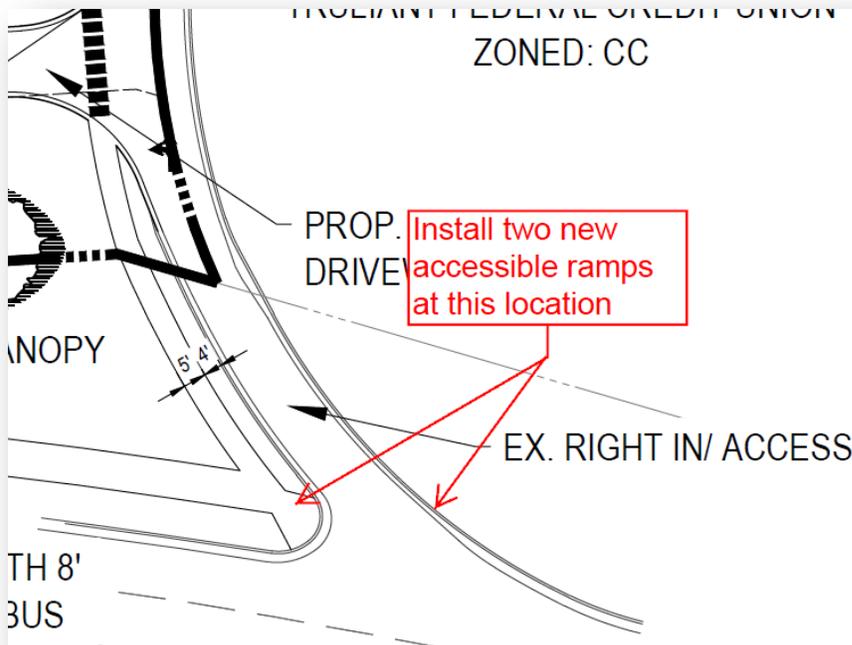
1. CDOT requests that the petitioner improve the pedestrian refuge island at the intersection of Nations Ford Rd. and Tyvola Rd. The existing ramps and sidewalks are not ideal for a safe pedestrian crossing environment. In addition, the mountable curb will not protect pedestrians from vehicles that may accidentally leave the roadway. Show the improvements on the site plan. See the proposed sketch below (conceptual only):
